Project: Wicks Farm, Ford

Project No: 6352

Subject: Response to West Sussex Highways request for additional Information.

Prepared by: Benjamin Boreham Date: 13/08/19

DATE	AUGUST 2019	DESIGN	BEB	DRAWN	DLW
DRAWING NO.	6352.001	SCALE	1:1000	SHEET	@ A2

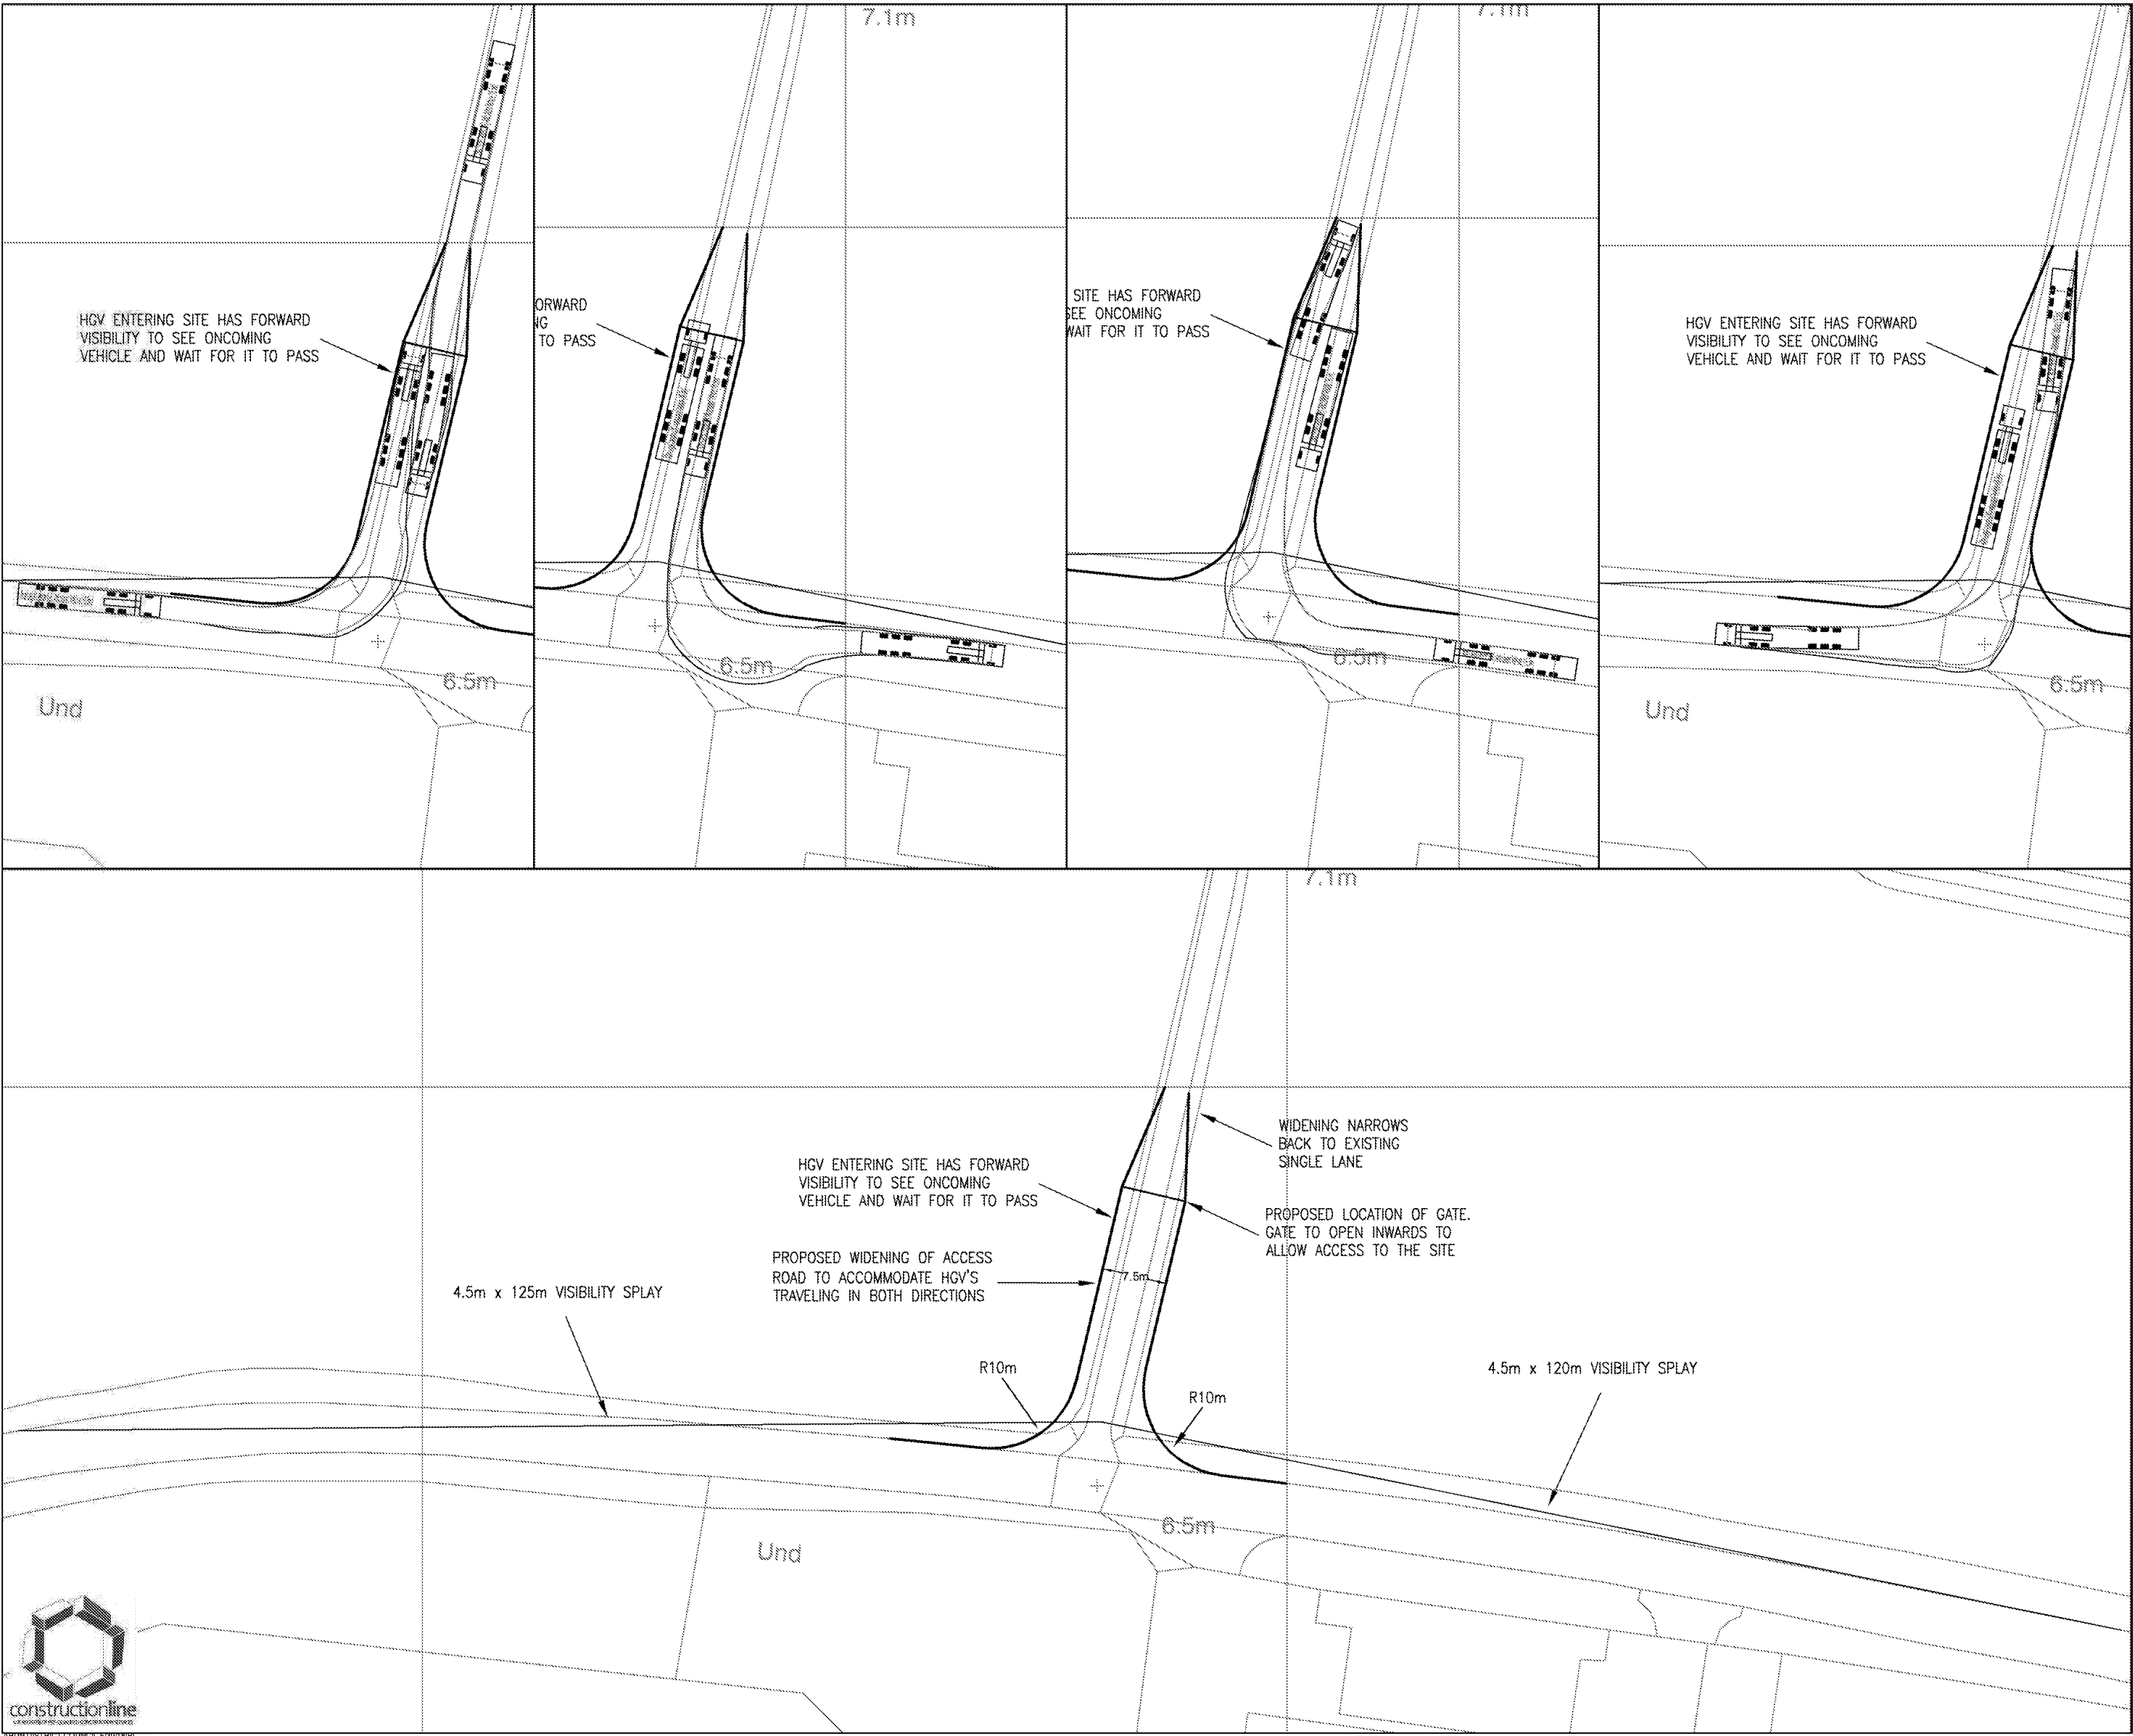
- A clear plan demonstrating the current and proposed width of the access and internal access route through the site, including details of the formalisation of the access.
- Clarification of ownership of land either side of the existing access.
- Swept path tracking demonstrating the largest anticipated vehicle entering the site, travelling through the site, turning and exiting the site.
- A seven day speed survey should be undertaken to determine 85th percentile speeds in this location. Visibility splays should be provided in accordance with these speeds.
- Vertical visibility at a distance of 4.5m back into the access for the full length of achievable vehicular visibility splays.
- Details of the type and number of movements per day at the existing access for the existing use.

- 1.9. The site will take access from an existing farm track with a junction onto Ford Lane. This access is currently not suitable for HGV's and will need to be improved in order to facilitate HGV movements for the development. SMA has undertaken a review of the existing access and has suggested a redesigned access solution, as shown in **Drawing 6352.001**.

- 1.10. The junction design shown in **Drawing 6352.001** shows, the access will be widened to 7.5m for the first 30m before narrowing back down to the existing width for the remainder of the length of the access road.

- 1.13. This allows an HGV to turn into the access road and, should another HGV be leaving the site at the time, be able to wait without any of the vehicle overhanging on to Ford Lane. The drawing shows that there is suitable space on this access for the HGV's to pass each other without causing an obstruction on Ford Lane.

- 1.17. The wet weather speeds are therefore used as the basis of the visibility splays for the proposed site access. The proposed visibility splays are therefore 125m on the westbound carriageway and 120m on the eastbound carriageway. These visibility splays are shown in **Drawing 6352.001**.

- 1.19. As **Drawing 6352.001** shows, there is no obstruction to the visibility splays in either direction from the access.
